Client: Thameside College
 Project: Construction Skills Building
 Job No.: 1072
 Date: 24/1/18
 BIM Model: TCCB-10A-V2-ZZ-M3-A-0001
 QA: ADS DWD
 Scale: As indicated/A1
 Drawing: Proposed Elevations
 Rev notes: r182 - Updated Planning Issue

TCCB-10A-V2-ZZ-DR-A-2540-L2

1 Proposed North Elevation
 1:200

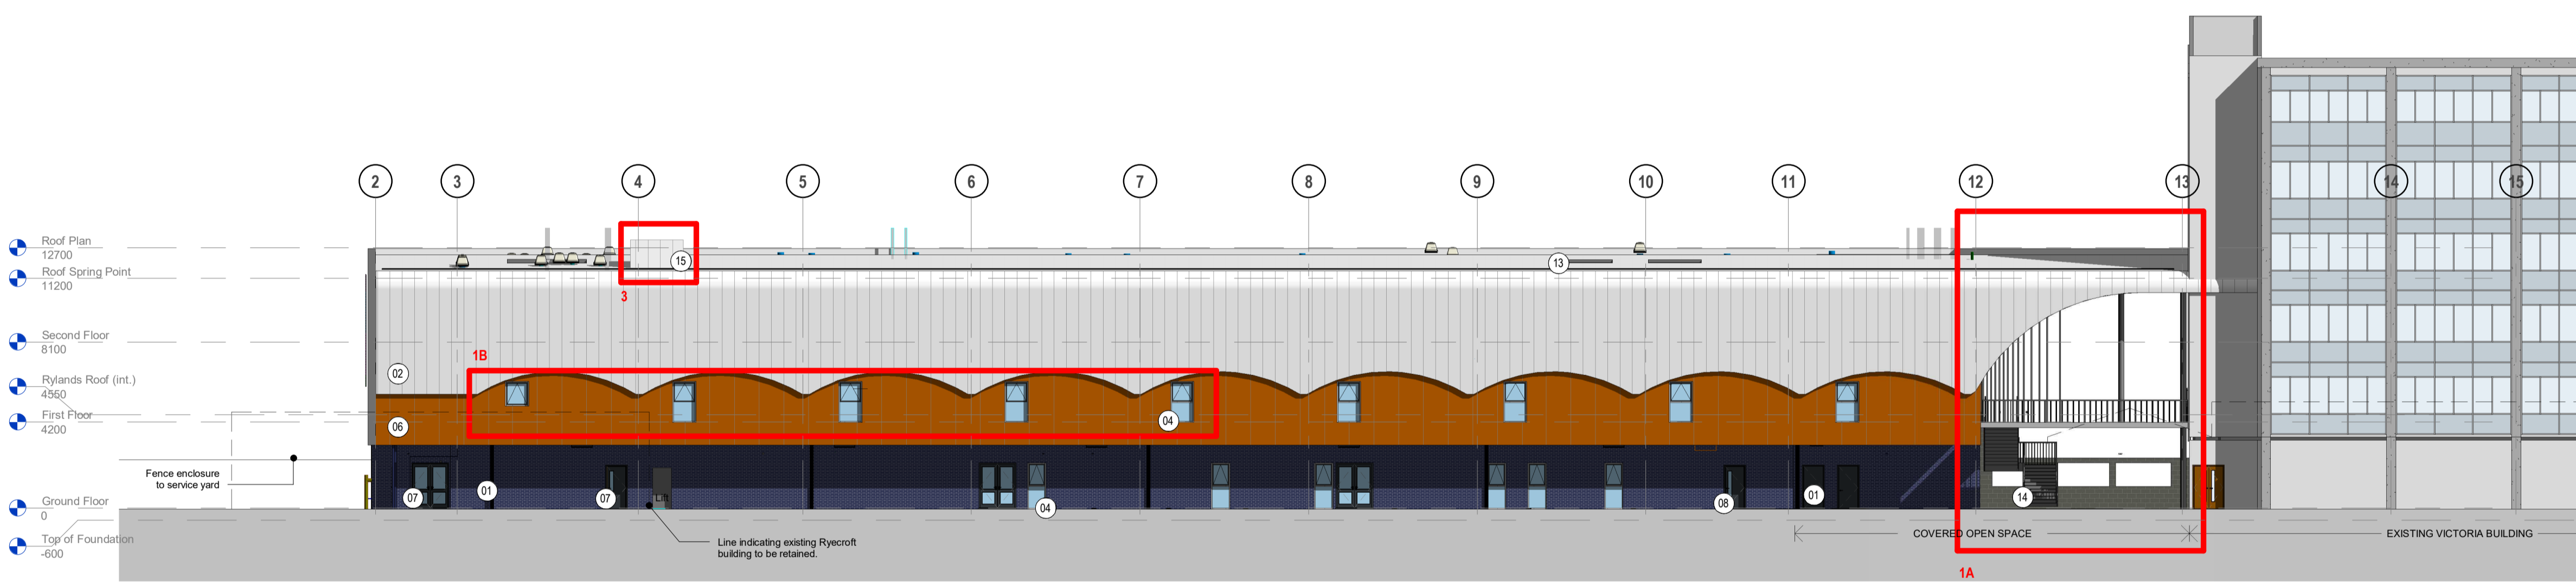
| 1. | - Directly relating to shift in building position.

a. Reduction of roof canopy length. The reduced length of canopy will absorb the entire shift of the building and the main intention of keeping the new building connected to the existing building will remain unchanged. Within this same area, the external stair location has been adjusted slightly to further underneath the roof canopy, providing better weather protection and easier movement around campus.

b. Adjusted heights of windows. On the rear elevation, due to the location of the existing Rycroft building, the sill levels of the windows can be updated to match the adjacent buildings on this elevation. However, one window will need to retain a higher level sill due to the Rycroft connection below.

c. Revised landscape works. Due to the reduced demolition, no external landscape works will be required to the areas containing the existing gas and plumbing buildings. Furthermore, as the building has shifted away from this area, a revised service yard and vehicle access route has been provided. This will also require less landscape works and disruption than the previously submitted design. |

| 2. | Reduced scope of demolition. Due to college requirements and as a result of the building shift, the following buildings will no longer need to be demolished: <ul style="list-style-type: none"> Gas & Plumbing Joinery Brickwork |
| 3. | Lift overrun. The lift design will now require an overhead clearance that will result in a penetration to the roof. This is located on the internal courtyard side and should not be visible from any public areas. To further minimise visual impact within the campus, the lift overrun will be clad in a standing seam metal system to match the roof. Roof above External Plant Deck omitted. A small portion of the main roof above the External Plant Deck is to be omitted. This would not be visible from anywhere in public or on campus and will remain concealed behind the parapet that will wrap around this corner of the building. |

3 Proposed West Elevation
 1:200

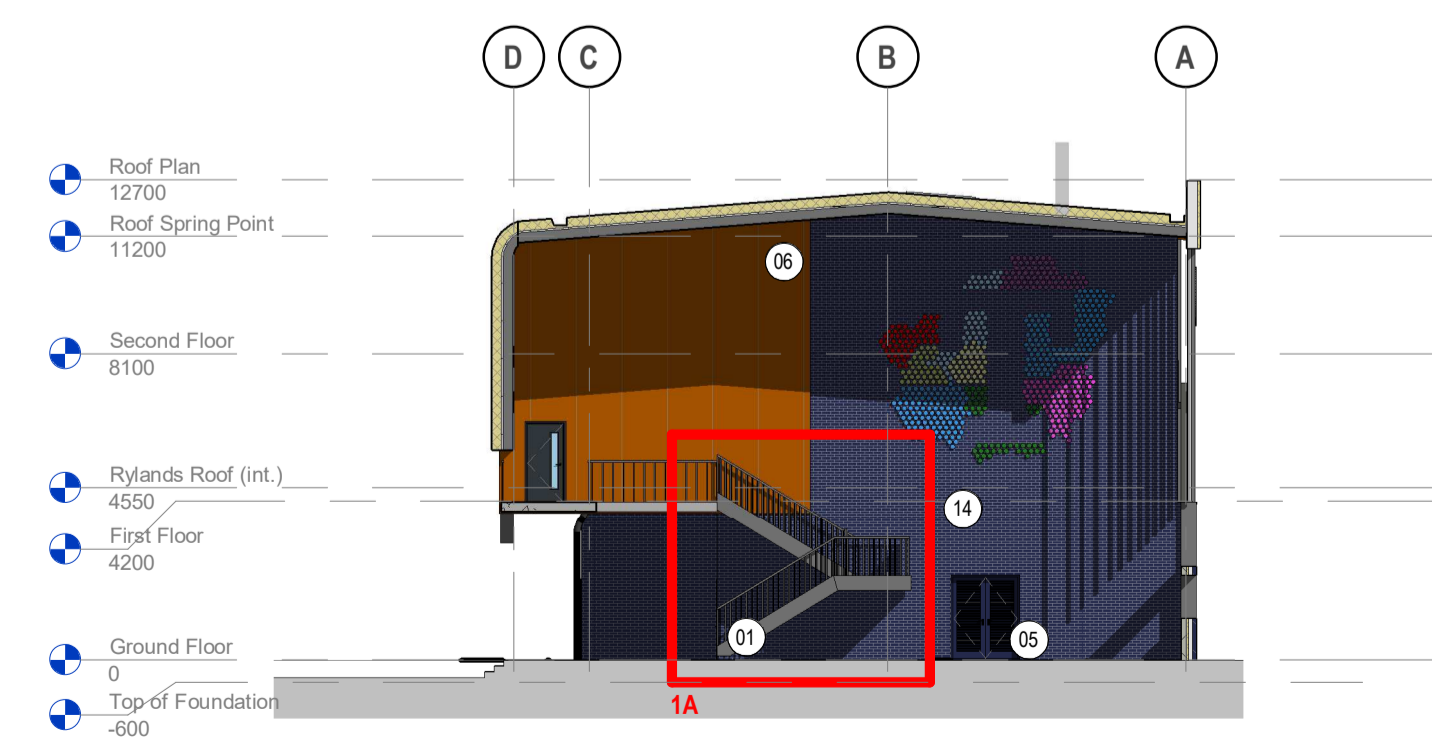
15	Head of lift to be clad in standing seam cladding to match roofwall cladding.
